SAN FRANCISCO PLANNING DEPARTMENT

2014-003127DRP

155 & 157 29th Street

Discretionary Review Abbreviated Analysis HEARING DATE: MARCH 10, 2016

Sample of Highlighted Revisions per DR Request

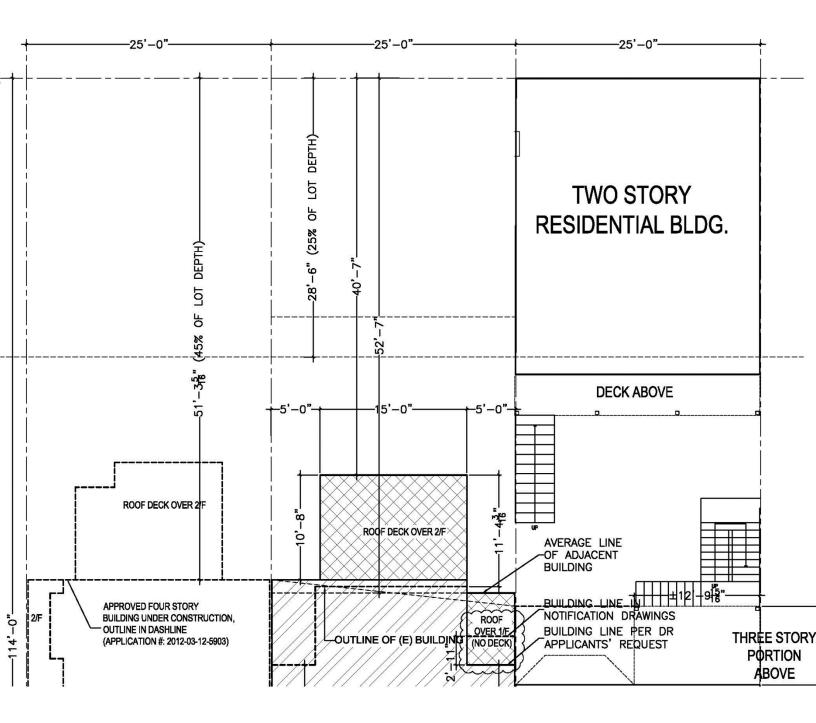
- The depth of the Subject Property's rear addition in the 5-foot existing side yard area at the west property line (see "Roof Over 1st Floor (No Deck)" label) has been reduced by 2-feet 11-inches at the second, third, and fourth floors – to maximize sunlight exposure for the DR Requestor.
- 2. The rear windows and doors have been removed from the west side, and moved to the east side of the two-story pop-out to respond to the DR Requestor's privacy concerns.
- 3. The rear façade will be painted in a light color per the DR Requestor's requests, noted on drawings (not related to Planning Code).

4. The roof deck railings at the 2nd and 4th floors have been revised to be clear glass to maximize sunlight exposure for the DR Requestor.

Matching lot line walls provides context (from 4th Floor of Sponsor proposal, with Applicants' edit of west lot line wall in red).

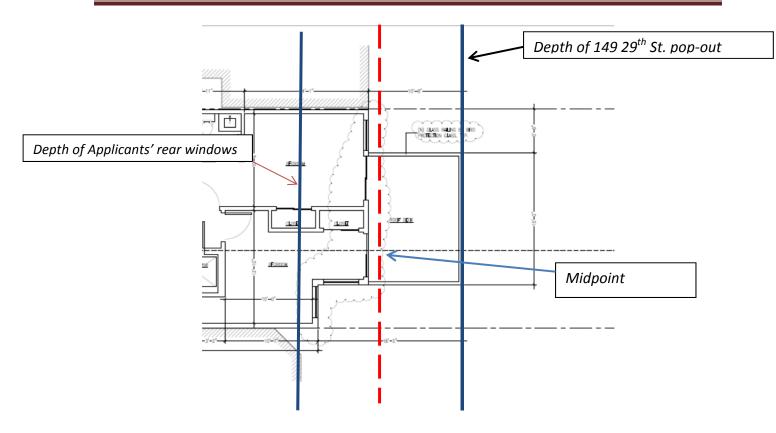
The diagram above, using the Sponsors proposed third floor plan, shows the midpoint between the depth of 149 29th Street on the east side of the subject property and the depth of the rear bay windows on the Applicants' main building.

Strong mid-block open space pattern on subject block.

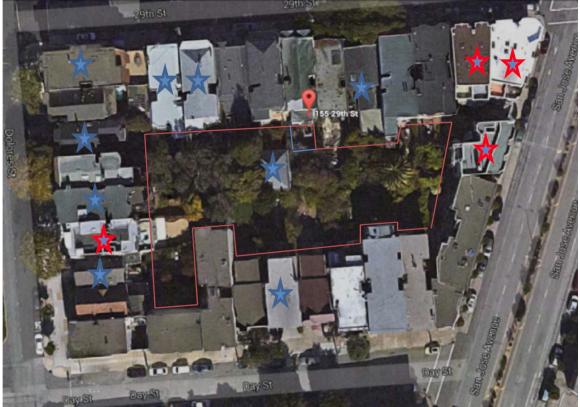
Also on the photo below, we have marked with blue stars those buildings on the block that we know have been substantially renovated in the last 20 years without going outside of the existing building envelope. These renovations were done by owners who intended to remain in their buildings, just like your clients. These owners were able to find ways to accommodate their needs within the existing context. It is regrettable that an expansion into the current garage and a full-story addition on top of the current envelope is not enough for your clients.

The block has also accommodated substantial new construction. Those buildings are marked with red stars. Those buildings have successfully blended into the mid-block open space, finding a compromise between new housing and preservation of that shared mid-block open space resource. The only exception to that was the new construction next to your clients' property.

That outlier would now become the rule under your proposal. We believe a balance should be achieved.
